SERVICE BULLETIN

SB 70-247

REVISION 1

SUBJECT : GARMIN G1000 NXi INTEGRATED FLIGHT DECK AND SOFTWARE V20.80
(P/N 006-B3086-00)

Figure 1 – FS 210 Removal – Wiring modification

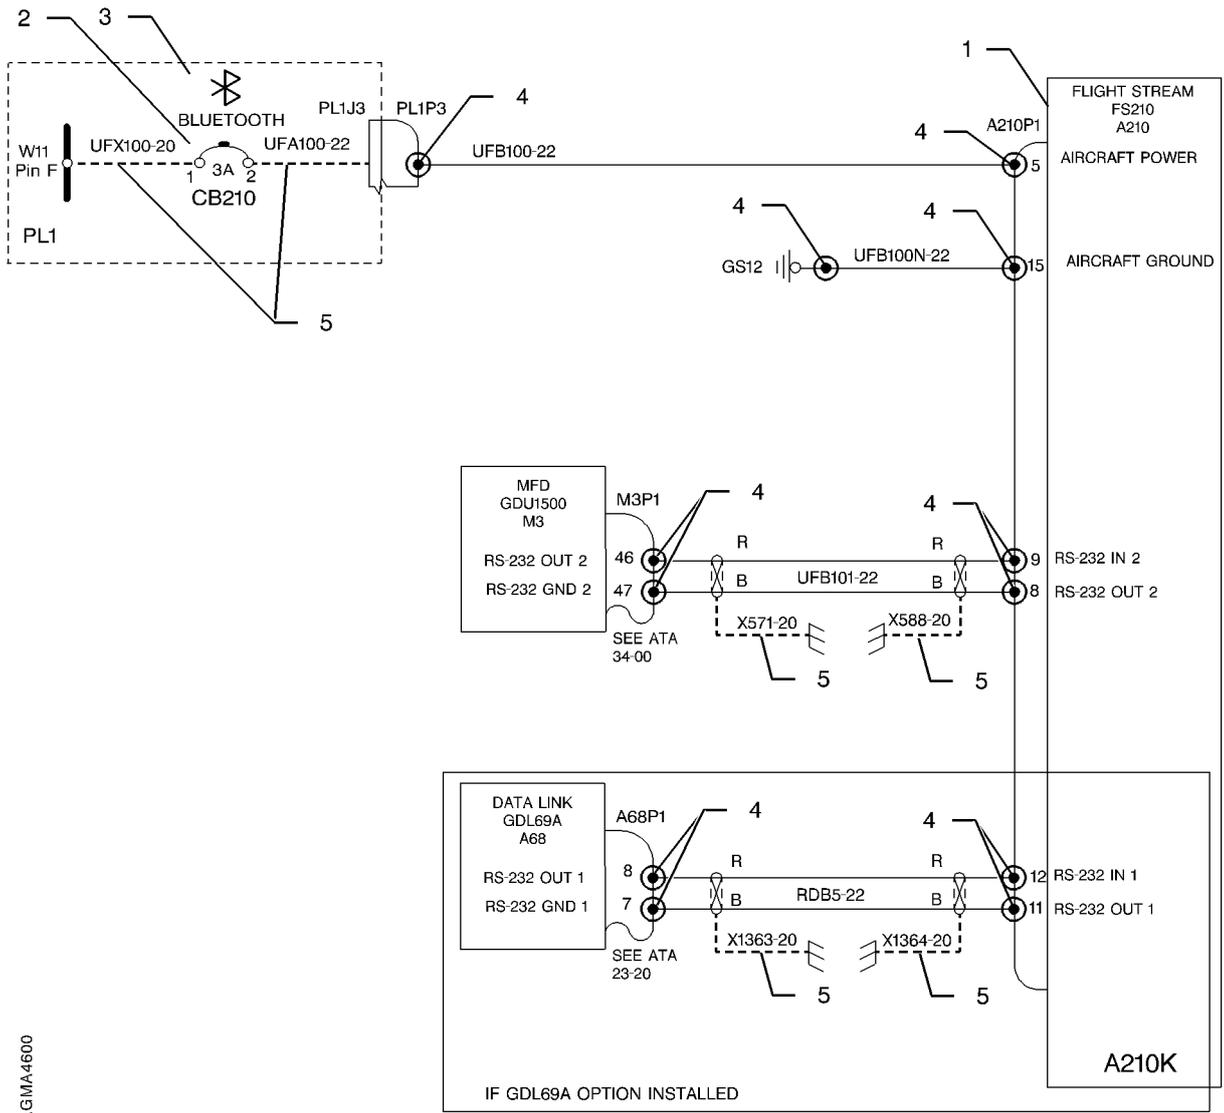
- 6) Remove the two upper screws and tilt PL1 panel without disconnecting it.
- 7) Remove and discard UFX100 and UFA100 wires.
- 8) Remove and discard X571 and X588 wires.
- 9) Remove and discard FS 210 circuit breaker (2) – refer to Chapter 24–60–01 page 401 of the Maintenance Manual and replace it by plug.
- 10) Unstick Bluetooth label.

- 11) Remove Flight stream 210 (1) – refer to Chapter 46-20-01 page 401 of the Maintenance Manual.

- 12) Cut and discard A210 P1 connector.
- 13) According to Figure 1, install insulated spare wire caps (4).

Figure 2A – TAS GTS 820 Wiring modification – Post-SB70-247-34

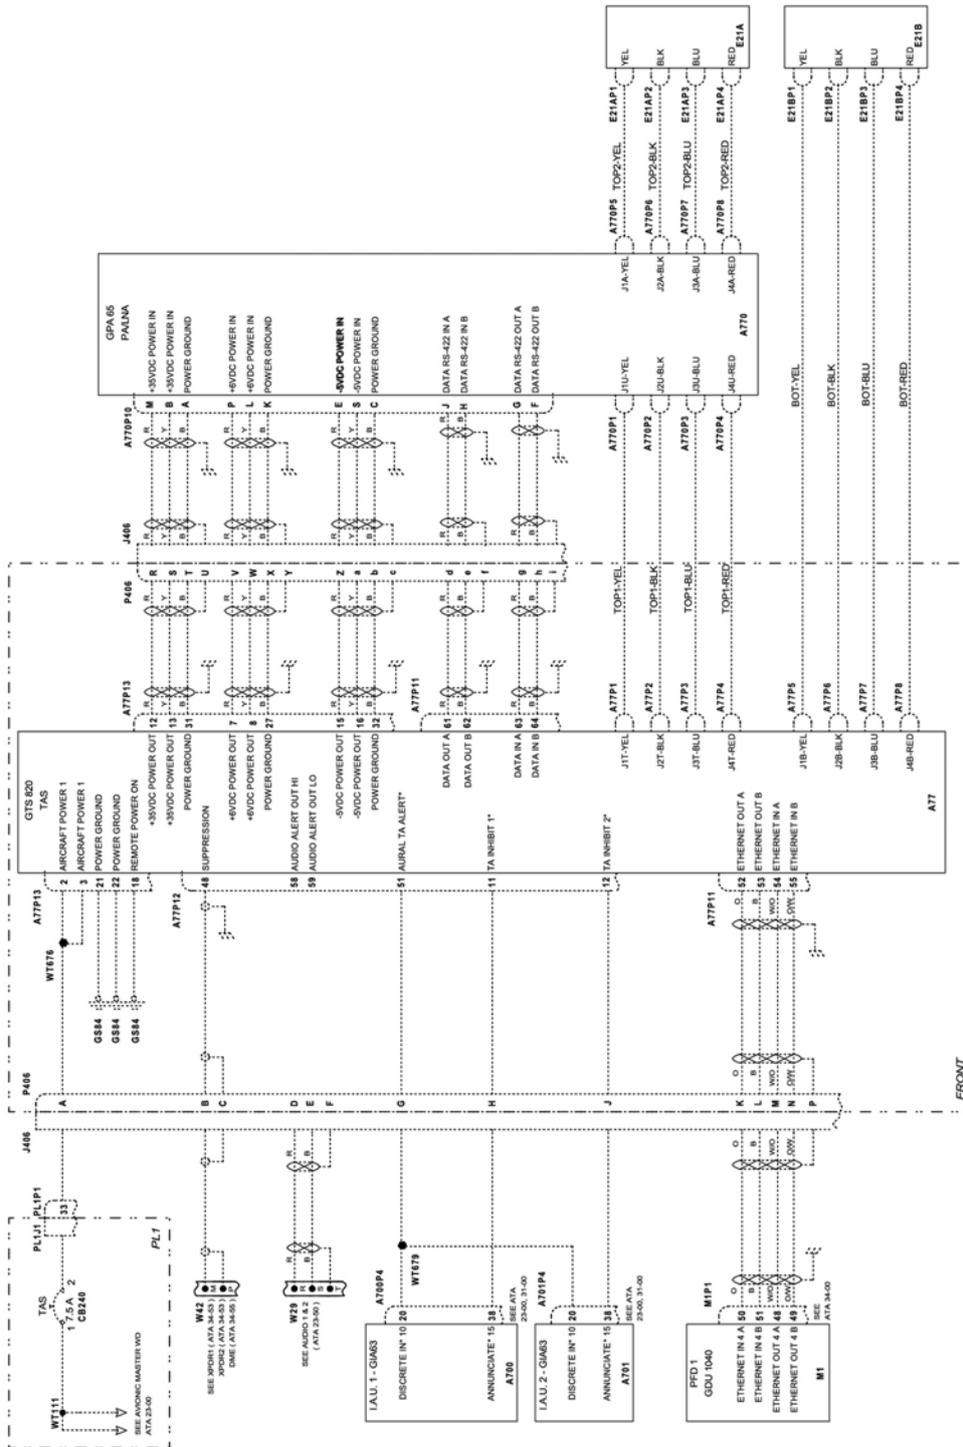
- 5) According to Figures 2 and 2A, remove and discard wires SHB42, X825 and X826 between connector P406 pins D, E and F and A77P12 connector pins 58 and 59.
